Subject: Class 1* Permit Modification Notification to the Waste Isolation Pilot Plant Hazardous Waste Facility Permit Number: NM4890139088-TSDF

Class 1* Permit Modification Notification
Changes to Groundwater Sampling Procedures
Waste Isolation Pilot Plant
Carlsbad, New Mexico
WIPP Permit Number - NM4890139088-TSDF

October 2017

Figure 1. H-19 Well Pad Configuration

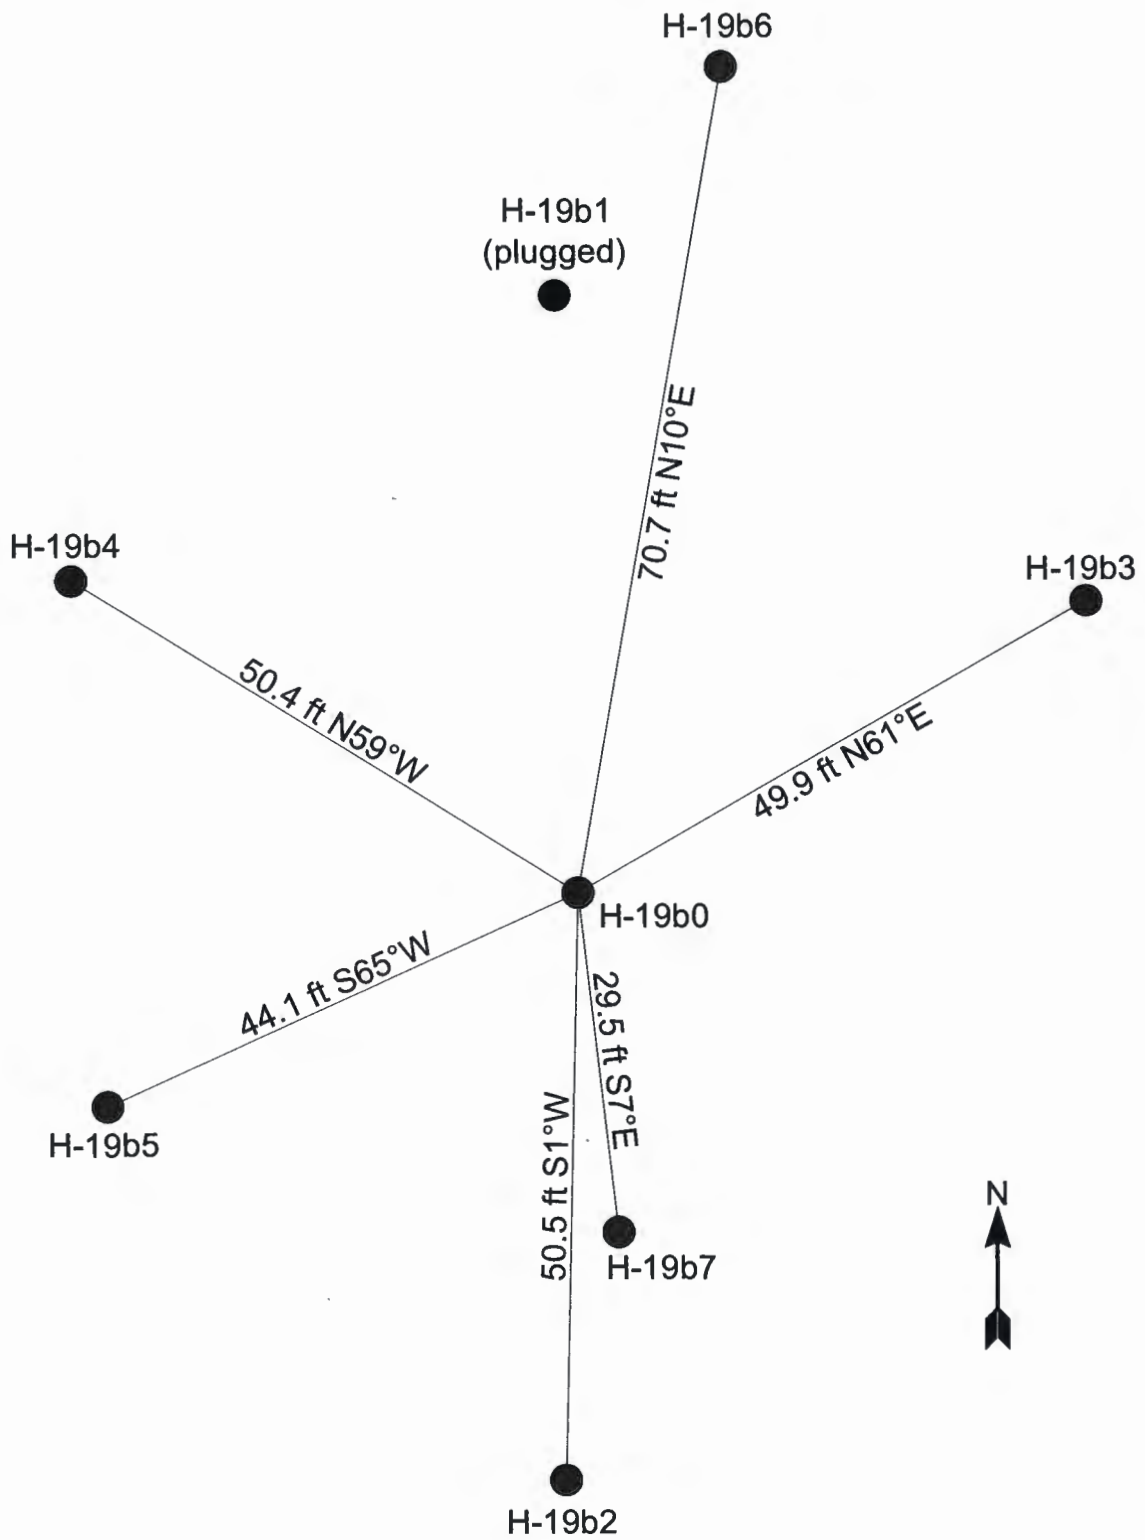
The Permittees are proposing to use the data from the in-situ pressure transducer at well H-19b0 to obtain an annual fluid density measurement that is functionally equivalent to the fluid density at the other wells on the H-19 pad and discontinue the manual downhole measurements. The rationale for making this change is as follows. The wells on the H-19 pad lie within a 71-foot radius of the H-19b0 well (see Figures 1 and 2). Data have shown that differences in the groundwater densities of the H-19 wells are negligible (see Table 1 below); therefore, using the data from the in-situ pressure transducer at the H-19b0 well is functionally equivalent to the data from individual measurements obtained from the H-19b2, H-19b3, H-19b4, H-19b5, H-19b6, and H-19b7 wells. The groundwater density measurements taken at well H-19b0 may be used to correct for freshwater head for Culebra groundwater wells H-19b2, H-19b3, H-19b4, H-19b5, H-19b6, and H-19b7. This change is needed to provide efficiencies in the Detection Monitoring Program (DMP) since the continuous in-situ pressure transducer measurements at well H-19b0 will replace the annual manual measurements at the other wells on the H-19 pad. This will allow the Permittees to discontinue the use of trailer-mounted measuring equipment and procedure WP 02-EM1021.
